# Access Compliance Report

## Public Rights-of-Way

Intersection ID: 42950	Main Street: BENZIGER_CT	Cross Street: LONG_PAW_LN	Location: SW
ADA ID: 5F675D4DA526	Ramp Type: Perp	Initial Pass/Fail: Fail	Overall Compliance: No
Severity Score: 8.75			
Codes/Mitigation Info/Possible Solution		Field Measurements/Component Compliance

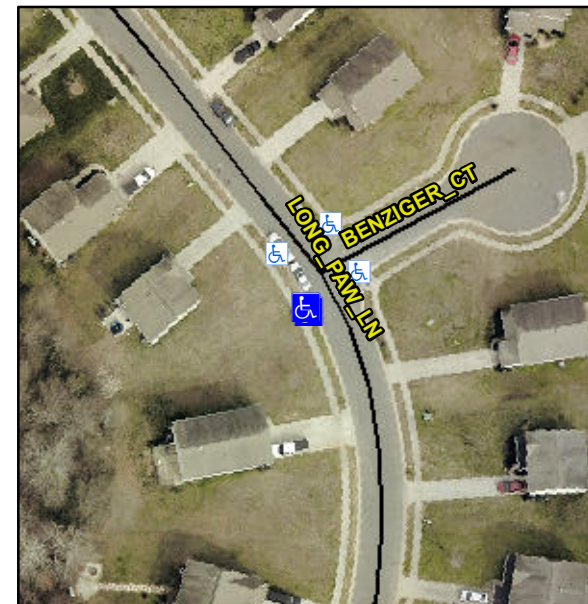
**Not Found, R304.5.1**

Compliance	Description	Data	Compliance	Description	Data
N/A	Ramp Length (in)	48.0	Yes	Ramp Slope (%)	8.0
No	Ramp Width (in)	47.0	Yes	Ramp XSlope (%)	1.5
N/A	Flare Type LT	N/A	N/A	Flare Type RT	N/A
N/A	Flare Slope LT (%)	N/A	N/A	Flare Slope RT (%)	N/A
N/A	Flare Traversable LT?	N/A	N/A	Flare Traversable RT?	N/A
N/A	Landing Length (in)	N/A	N/A	DWS Provided?	N/A
N/A	Landing Width (in)	N/A	N/A	DWS Contrast?	N/A
N/A	Landing Slope (%)	N/A	N/A	DWS Length (in)	N/A
N/A	Landing X Slope (%)	N/A	N/A	DWS Full Width?	N/A
N/A	Landing Curb? (Y/N)	N/A	N/A	DWS Offset (in)	N/A
N/A	Shared Landing?	N/A			
N/A	Gutter Ponding?	N/A	N/A	Gutter Slope (%)	N/A
N/A	Gutter Lip Ht (in)	N/A	N/A	Gutter X Slope (%)	N/A
N/A	Painted X Walk1?	No	N/A	Painted X Walk2?	N/A
	X Walk 1 Direction	To E		X Walk 2 Direction	N/A
N/A	X Walk 1 Width (in)	N/A	N/A	X Walk 2 Width (in)	N/A
	X Walk 1 Slope (%)	3.4		X Walk 2 Slope (%)	N/A
	X Walk 1 X Slope (%)	1.6		X Walk 2 X Slope (%)	N/A

**Remove & Replace Entire Ramp.**
